Site 10 ground contamination: response to s92 request

This letter provides responses to Wellington City Council (WCC)'s s92 request for information dated 5 February 2015, which in turn references a letter prepared by URS dated 16 January 2014 (subject: *Contaminated land and HSNO Advice Related to Land Use Consent Application at 10 Waterloo Quay SR No. 309386*). We have prepared this report in accordance with our existing engagement, dated 8 April 2015.

**Ground Contamination Assessment
Wellington Waterfront Sites 8, 9, 10**

**Sites 8, 9, and 10
DRAFT Contamination Site
Management Plan**

Figure 2: excavation zones within Site 10 basement

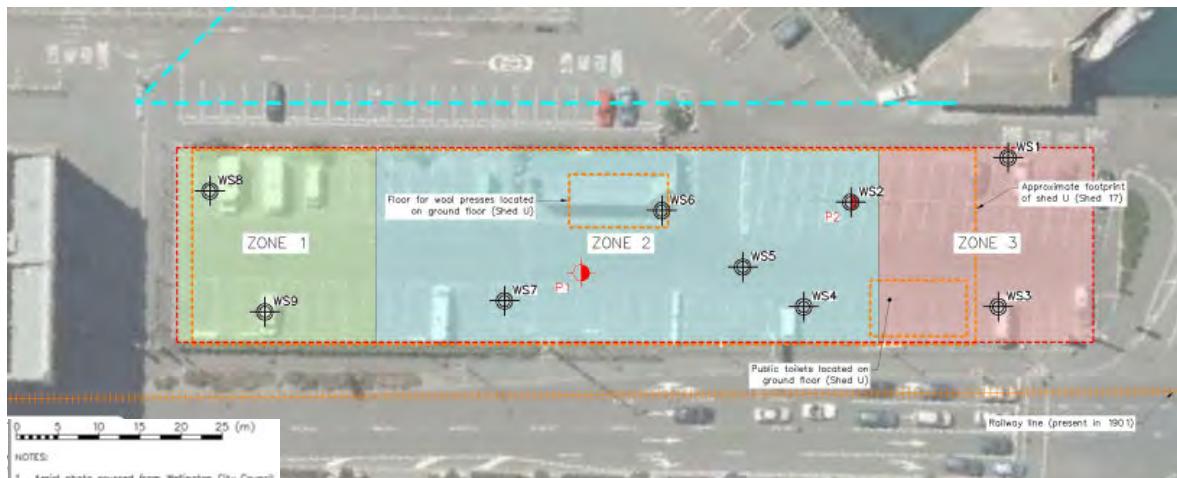
URS Comment on Draft CSMP	Response
<p>Section 3.3: We do not consider dividing the site into three soil management zones has been substantiated. We recommend this section of the Draft CSMP be modified accordingly.</p>	<p>The assessment was based on review of soil strata in borelogs, as described above. The intention is to identify where layers of clean soil may potentially be present.</p> <p>The Draft CSMP requires further testing before any material is disposed to clean fill. We have revised Table 2 and Section 5.2 to clarify this material is “potentially” clean (note, we have also updated Section 6.4 of the GCA to clarify that material is potentially clean, pending confirmatory testing).</p>
<p>Section 4.1: we do not consider there has been sufficient assessment for the presence of ACM in shallow soils (less than 1 m deep). We recommend this section be modified to require assessment of surface soils when the asphalt is removed.</p>	<p>We agree. Text added to Section 4.1 to clarify the process for this.</p>
